**Type of Submission:** Notice of Intent

**Type of Action:** Plug and Abandonment

STERLING SILVER 33 011

NOI TO PERMANENTLY ABANDON THIS WELL VIA CEMENT PLUGGING.

PROPOSED WELLCBORE

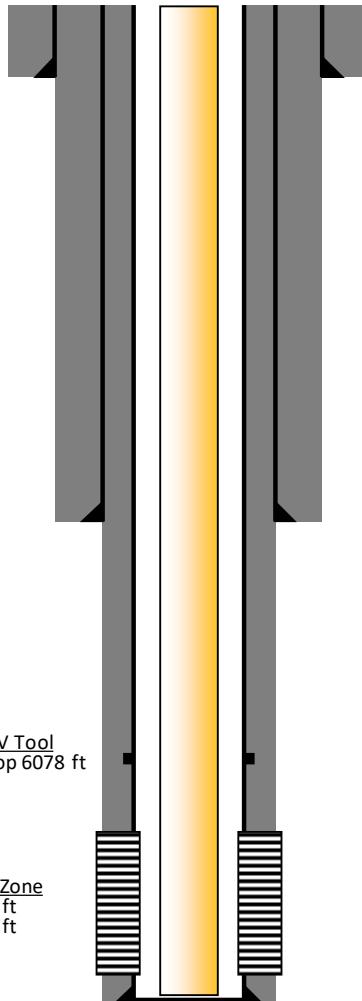
OK AS PROPOSED

Created By	Condition	Condition Date
gcordero	Add cement to step 6. cement must be from 4325' - T Bell Canyon	12/24/2025
gcordero	Adhere to current Plug & Abandon (P&A) Conditions Of Approvals (COA).	12/24/2025
gcordero	A Cement Bond Log (CBL) is required to be submitted to electronic permitting.	12/24/2025
gcordero	Submit Cement Bond Logs (CBL) prior to submittal of C-103P.	12/24/2025
